Z-31  
(2009)

# DON WESTBROOK

695 PIEDMONT ROAD  
LAND LOT 566, 16th DISTRICT  
OF COBB COUNTY, GEORGIA  
PIN: 18056600010

**ZONING DIVISION COMMENTS:** Staff Member Responsible: John P. Pederson, AICP

ISSUING PLAN FOR: **DON WESTBROOK**

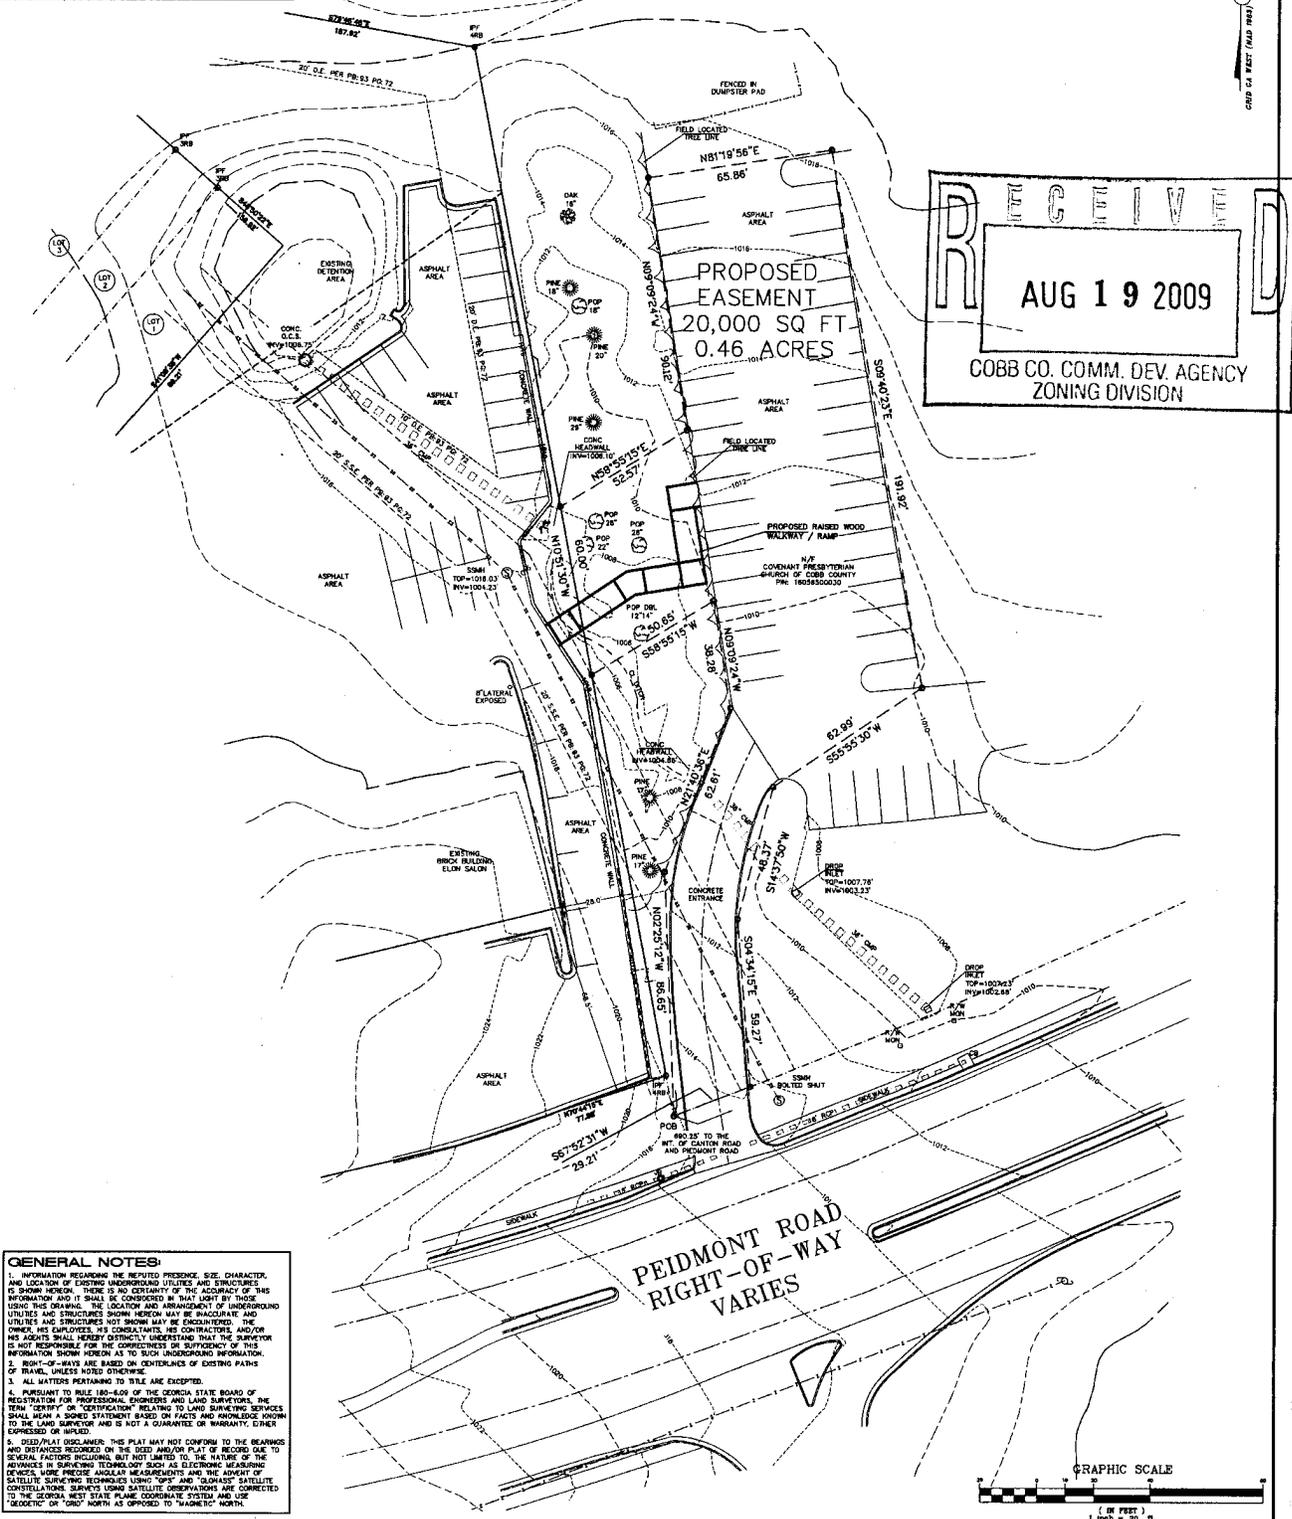
Notes FYI: *Proposed additional parking does not conflict w/CCWS water/sewer. 695 Piedmont Rd is connected to water/sewer & is not expanding*

- No Stormwater controls shown \_\_\_\_\_
- Copy of survey is not current – Additional comments may be forthcoming when current site conditions are exposed.
- No site improvements showing on exhibit.
